AMENDMENT TO OPERATING LICENSES NPF-4 AND NPF-7
NORTH ANNA POWER STATION UNIT NOS. 1 AND 2
PROPOSED TECHNICAL SPECIFICATION CHANGE

Safety Evaluation for
A Positive Moderator Temperature Coefficient

North Anna Power Station

TECHNICAL SPECIFICATIONS CHANGES FOR

MODERATOR TEMPERATURE COEFFICIENT
VS. POWER LEVEL

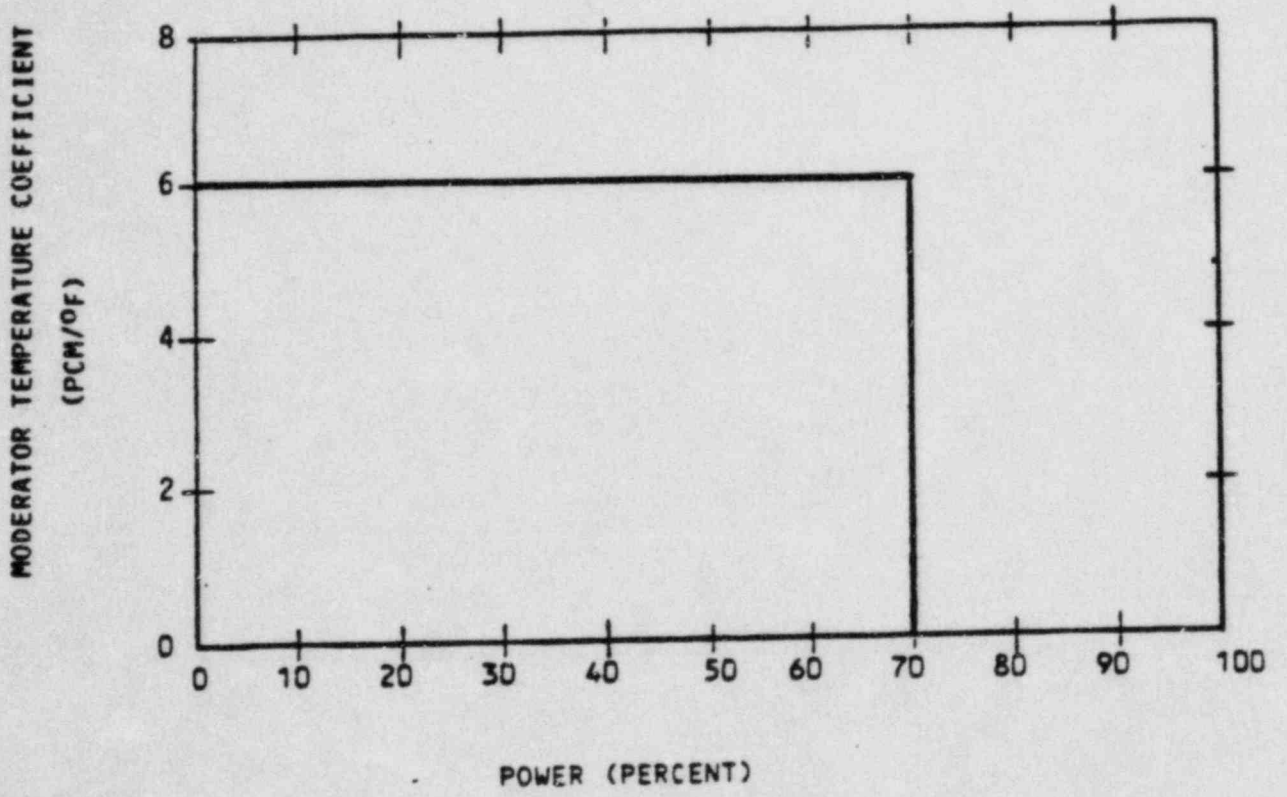
The proposed Technical Specifications change, given in Enclosure 2, allows a +6 pcm/°F* MTC below 70 percent of rated power, changing to a 0 pcm/°F MTC at 70 percent power and above. This MTC is depicted in Figure 1. A power-dependent MTC was chosen to minimize the effect of the MTC upon accidents initiated from high power levels. Also, normal core physical phenomena described above result in MTC becoming more negative as power level increases. This Technical Specifications change is expected to provide a reasonable degree of flexibility in core design and plant operation for future cycles of North Anna Units 1 and 2. The proposed changes are similar to those which have been approved for the Trojan and Turkey
